ADVISORY
BULLETIN

No. 2000-15
(Mercury Jet Drives No. 2000-03)

Official Recall Notification Federal Boat Safety Act Voltage Regulator – 240 HP Jet Drive

240 HP M² Jet Drives – 2000 and 2001 Model year product

a - Voltage Regulators

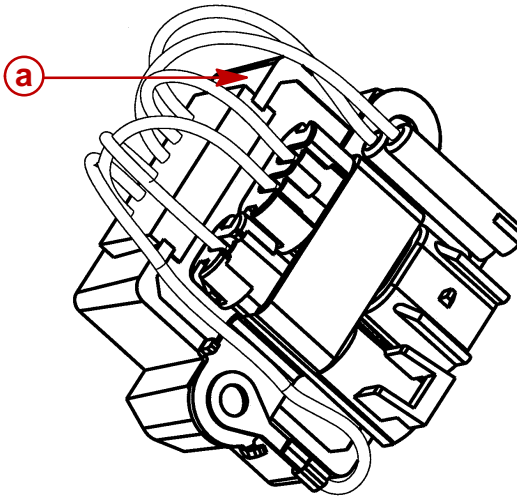
Voltage regulators in use on products identified above are at risk for experiencing an electrical short. A short, if it occurs, could be an ignition source for any flammable material in close proximity to the voltage regulator. Because of this potential for fire or explosion, Mercury Marine will replace the voltage regulators on the affected 240HP M² Jet Drives as listed above.

Qty. two (2) regulators – part number : 883072T1

a - Location of Green Dot

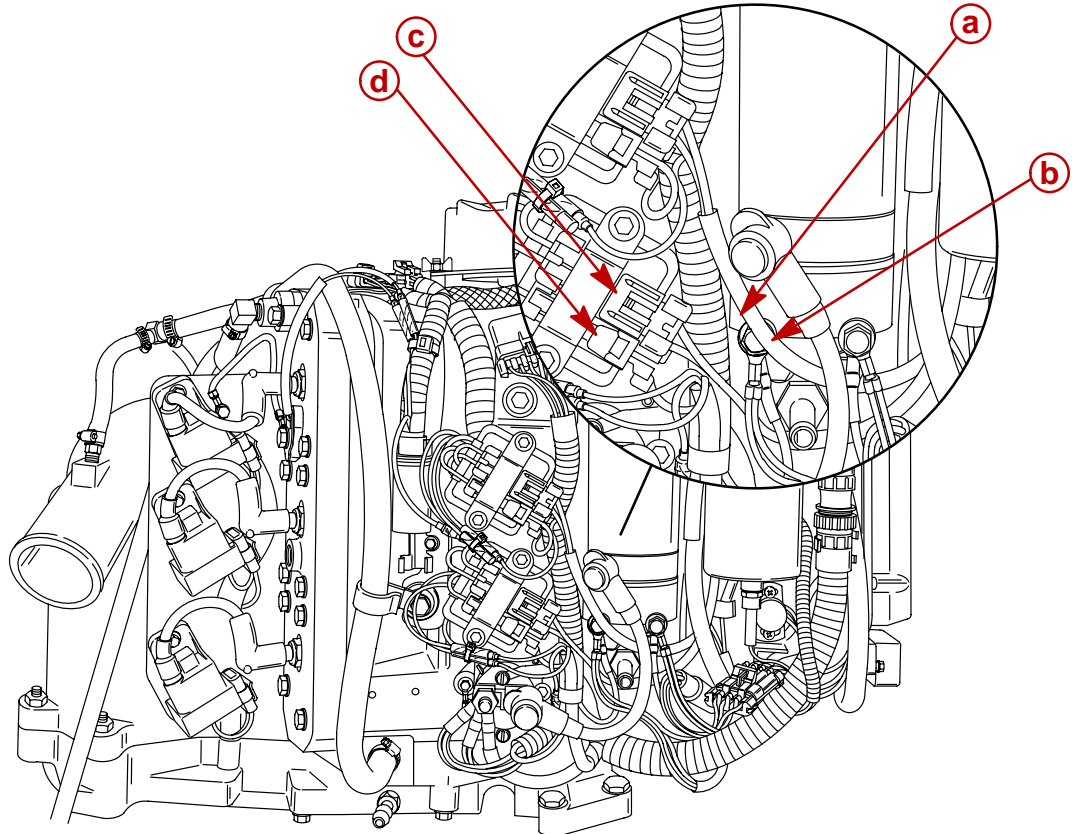
Visually inspect the voltage regulators in **your** parts inventory. A **GREEN** paint dot is located next to the grommet where the wires exit the regulator. There is a part number (883072-1) printed on the side of the regulator. If the regulators do not have these identification marks, **DO NOT USE THEM FOR REPLACEMENTS. REMOVE THEM FROM YOUR INVENTORY, AND USE ONLY THOSE REGULATORS SPECIFIED IN THIS BULLETIN. Complete a warranty claim referencing this bulletin and return those regulators to Mercury Marine.**
